Access Compliance Report Public Rights-of-Way (Curb Ramps)

Intersection ID: N/A Main Street: SHARON_VIEW_RD Cross Street: LOUISBURG_SQUARE_LN Location: NW
ADA ID: 81A75111357C Ramp Type: Perp Initial Pass/Fail: Fail Overall Compliance: No Severity Score: 1.25

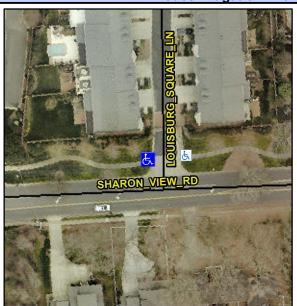
Pielu Measurements/Component Compilance						
	oliance Description	Data		oliance Description	Data	
N/A	Ramp Length (in)	54.0	Yes	Ramp Slope (%)	5.8	
Yes	Ramp Width (in)	60.0	No	Ramp XSlope (%)	2.4	
N/A	Flare Type LT	N/A	N/A	Flare Type RT	N/A	
N/A	Flare Slope LT (%)	N/A	N/A	Flare Slope RT (%)	N/A	
N/A	Flare Traversable LT?	N/A	N/A	Flare Traversable RT?	N/A	
N/A	Landing Length (in)	N/A	N/A	DWS Provided?	N/A	
N/A	Landing Width (in)	N/A	N/A	DWS Contrast?	N/A	
N/A	Landing Slope (%)	N/A	N/A	DWS Length (in)	N/A	
N/A	Landing X Slope (%)	N/A	N/A	DWS Full Width?	N/A	
N/A	Landing Curb? (Y/N)	N/A	N/A	DWS Offset (in)	N/A	
N/A	Shared Landing?	N/A				
N/A	Gutter Ponding?	N/A	N/A	Gutter Slope (%)	N/A	
N/A	Gutter Lip Ht (in)	N/A	N/A	Gutter X Slope (%)	N/A	
N/A	Painted X Walk1?	No	N/A	Painted X Walk2?	N/A	
	X Walk 1 Direction	To E		X Walk 2 Direction	N/A	
N/A	X Walk 1 Width (in)	N/A	N/A	X Walk 2 Width (in)	N/A	
	X Walk 1 Slope (%)	0.8		X Walk 2 Slope (%)	N/A

/Possible Solution	
Possible Solutions:	
Remove & Replace Entire Ramp.	
Surveyor Notes:	
N/A	
PROW/ADA:	
R304.5.3	
R304.5.3
